MEMORANDUM

To: Zoning Board
From: Lauren A. Wasilauski, Open Space & Stewardship Director
Date: November 22, 2022
Re: BA-02-22 Golden Bison Investments, LLC
Block 11002 Lots 14 & 15 (52 Zion Wertsville Road)
Bulk Variances

Applicant's property outlined in red, with locations of presumed dead trees indicated with yellow arrows.

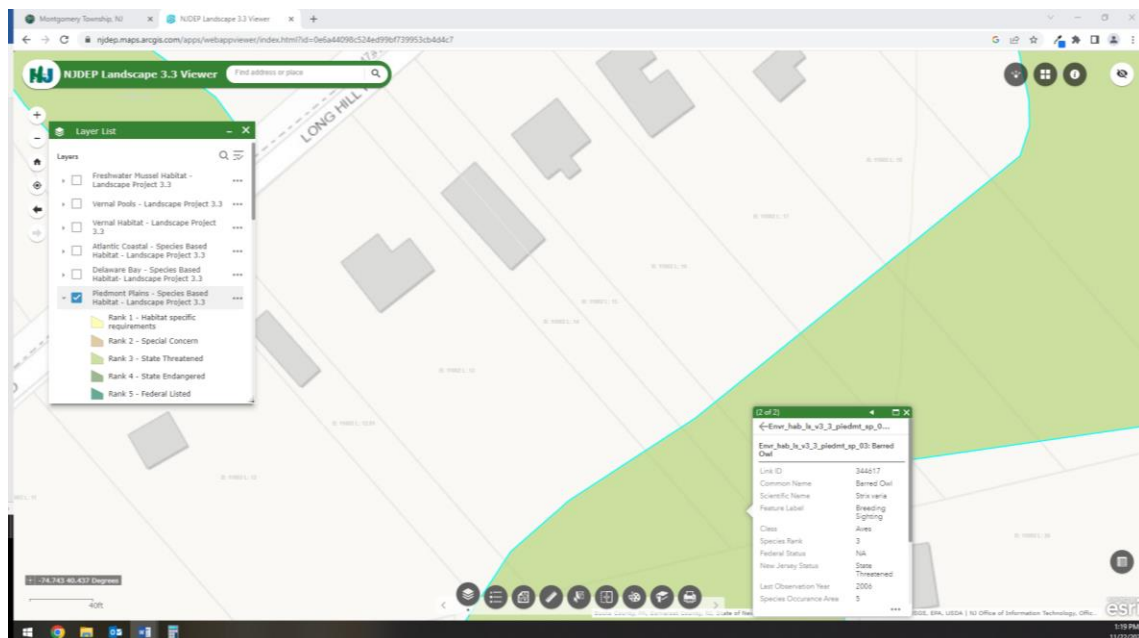
3. Shade Trees: 14 trees per acre are required for residential and non-residential development per Township Code Section 16-5.6d.3.
 - a. Based on the ordinance requirement and an acreage (after ROW dedication) of 0.457 acres, a total of 6 trees are required.
 - b. The Applicant's plans indicate that seven (7) shade trees are proposed. However, the landscape schedule lists seven (7) Green Giant Arborvitae. The landscaping and buffering requirements of Code Section 16-5.6d.13 are separate than the shade tree requirement and do not count toward the shade tree calculation.
 - c. According to the June 29, 2022 NearMap aerial image (see below), there appear to be a number of dead trees at the rear of the property. This office would encourage the Applicant to plant the shade trees in this area (with appropriate deer protection) to replace those that have died.
